Licence Number L8721/2013/1

Licence Holder Karara Mining Limited

Premises Karara Minesite Beneficiation Plant
M59/644, M59/645, G59/38 and L59/99
PERENJORI
WA 6620

Amendment

Figure 1 TSF 2A layout - original design as approved in Amendment Notice 2, 8 January 2018

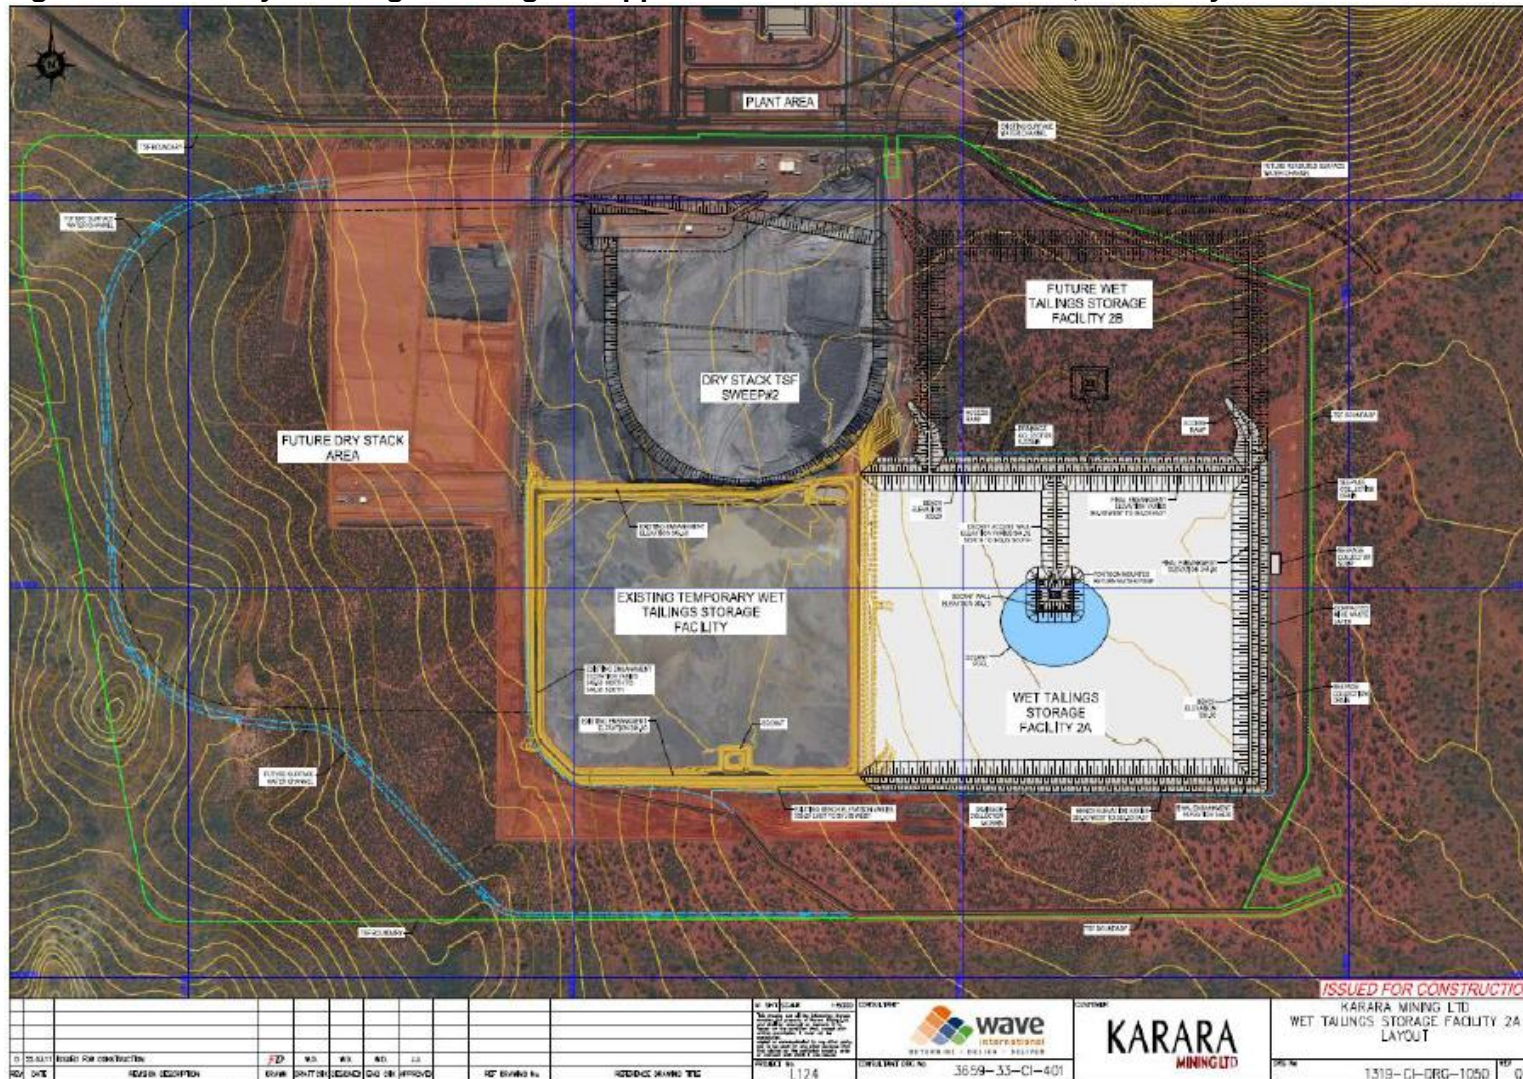
Figure 1 below is the existing design plan of TSF 2A and Figure 2 below shows the updated TSF2A plan with the temporary dividing wall which creates and separates Cell 1 and Cell 2.

Figure 3: TSF 2A – typical section showing the location of the internal embankment

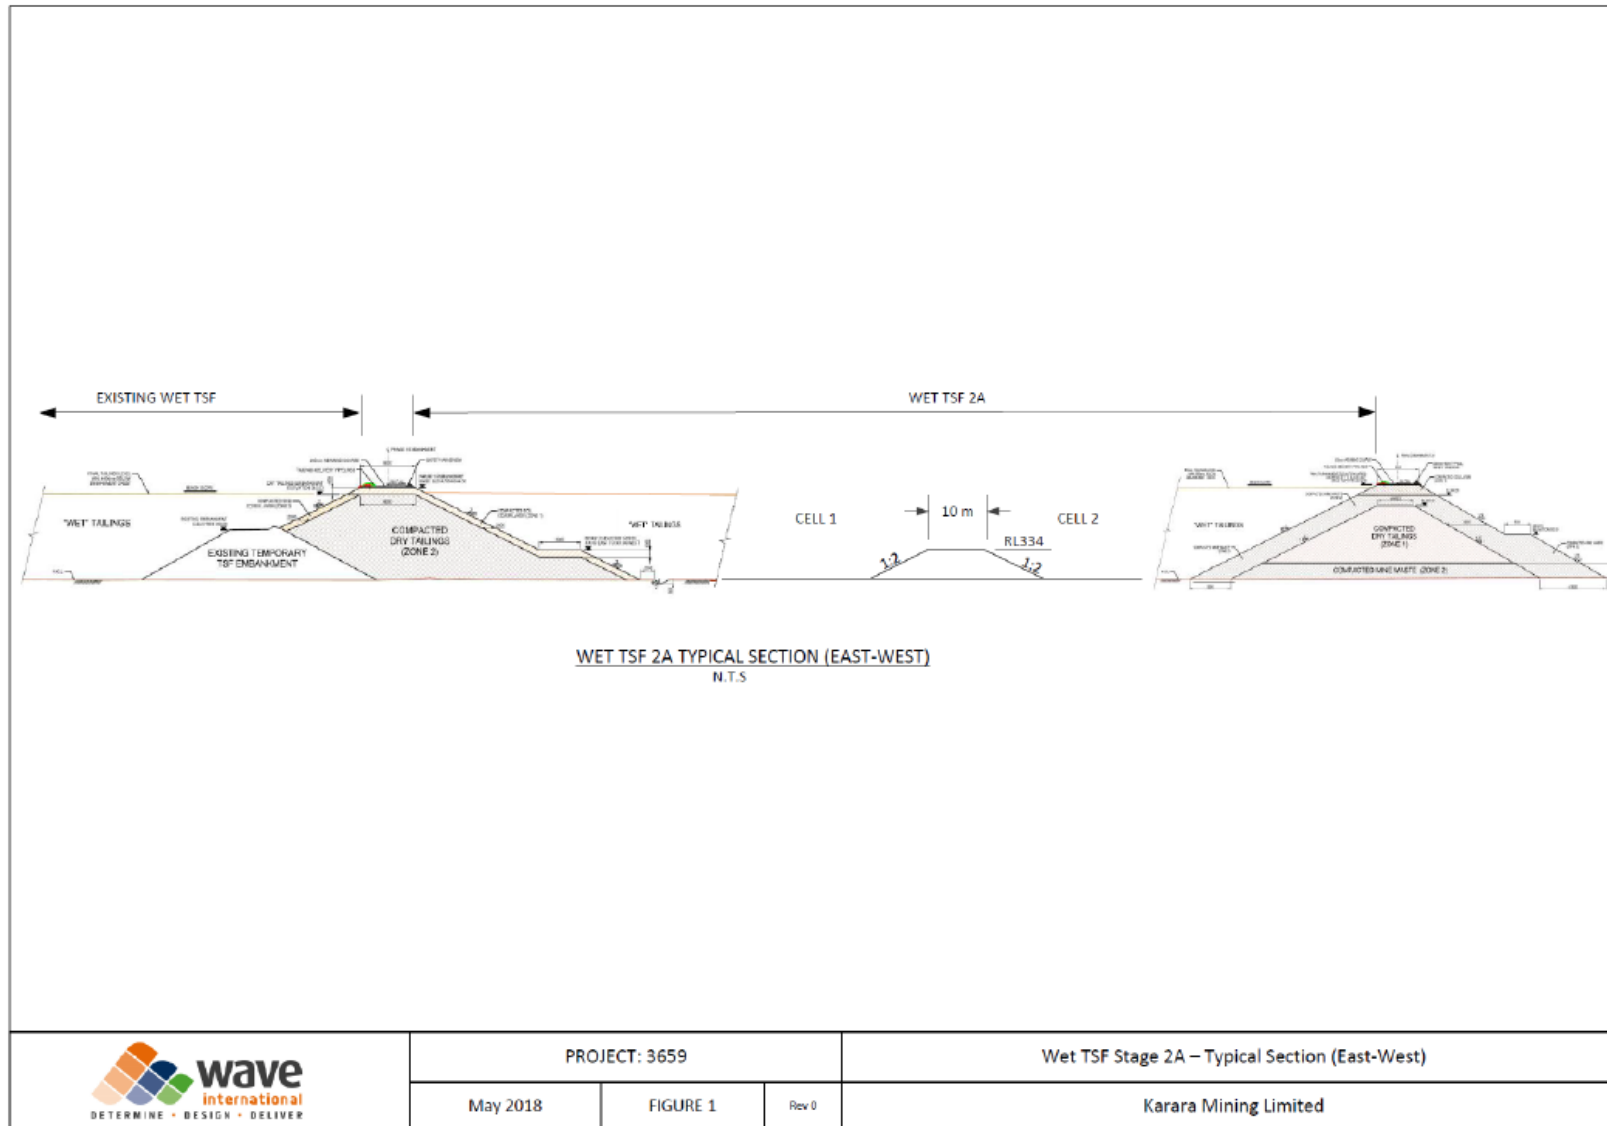
The proposed internal embankment will be 10 m high and approximately 340 m in length and extends from the central decant tower to the middle of the southern embankment wall of TSF 2A. It will be constructed with Colluvium materials (mainly Gravelly Silty Clay/Gravelly Silt) sourced from the upper layers of the immediate surroundings of the dam.

The permeability of the Colluvium materials proposed for the internal embankment is 1.0×10^{-8} m/s in accordance with the existing licence. The embankment's batter angles will be 2H: 1V. Figure 3 below is a drawing for typical section.

Map 6: Layout of TSF 2A (Cell 1 and Cell2)

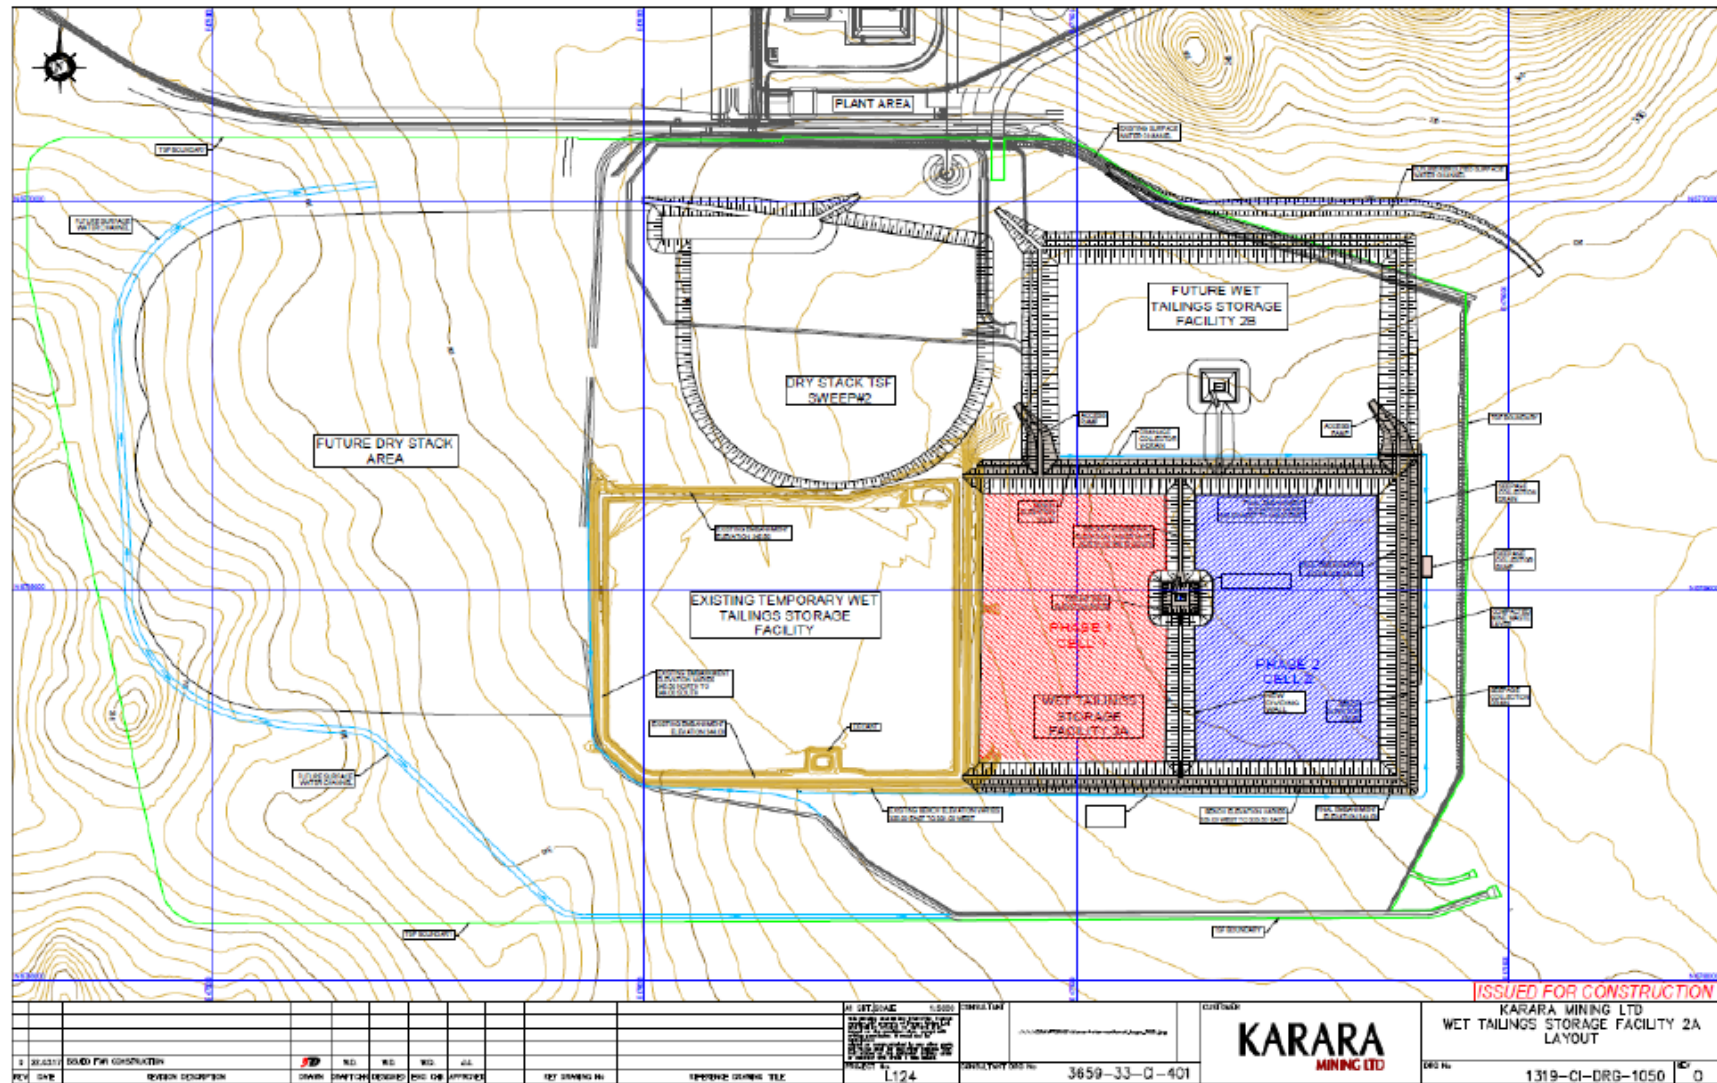
10. Schedule 1: Map 6 of the Licence is amended by the deletion of the map crossed by red line below and the insertion of the map titled Map 6 in red underline as denoted as Map 6 below.
11. Schedule 1: Map 8 of the Licence is amended by the deletion of the map crossed by red line below and the insertion of the map titled Map 8 in red underline as denoted following.
12. The Schedule of the Licence is amended by the insertion of Map 9 titled 'Groundwater monitoring bore locations' as denoted in red underline following.
